CLIENT
ZANCOR HOMES

PROJECT/LOCATION
OLDE WINCHESTER
BROOKLIN, ONT

DRAWING
SITE GRADING PLAN

LOT NUMBER
111

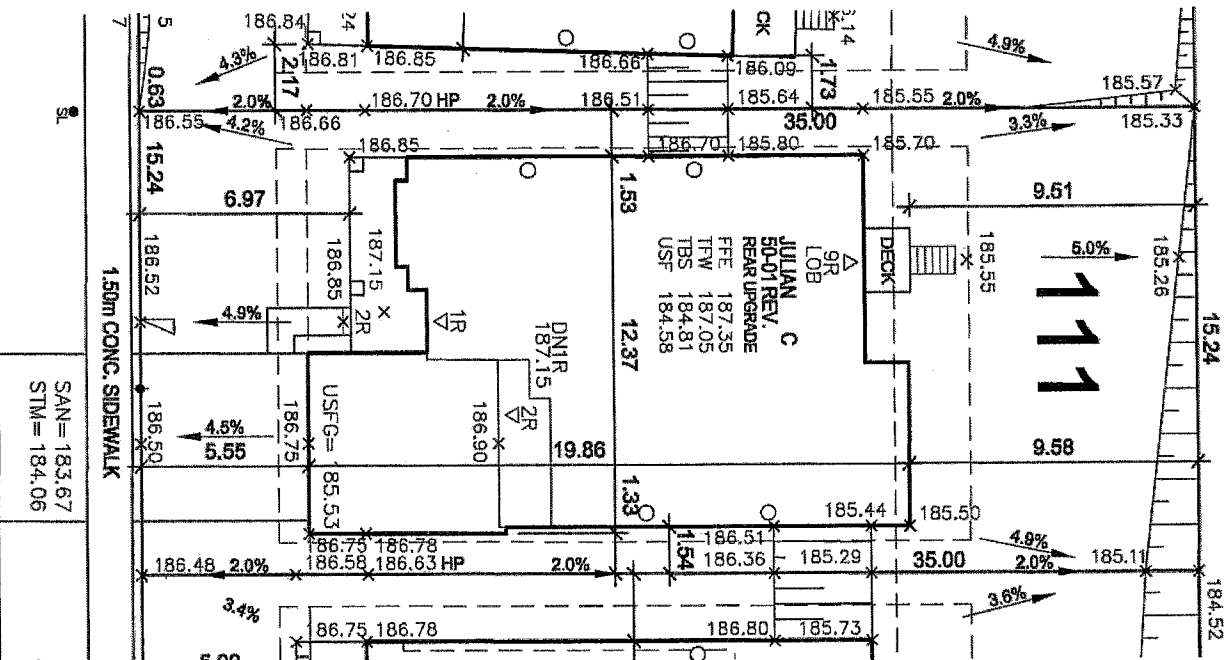
UPGRADE EXPOSED ELEVATION(S)
(See Approved Streetscape / Unit Working Drawg)

FOOTING TO BE EXTENDED TO 1.25 (MIN) BELOW GRADE	FOOTING TO BE EXTENDED TO 1.25 (MIN) BELOW GRADE
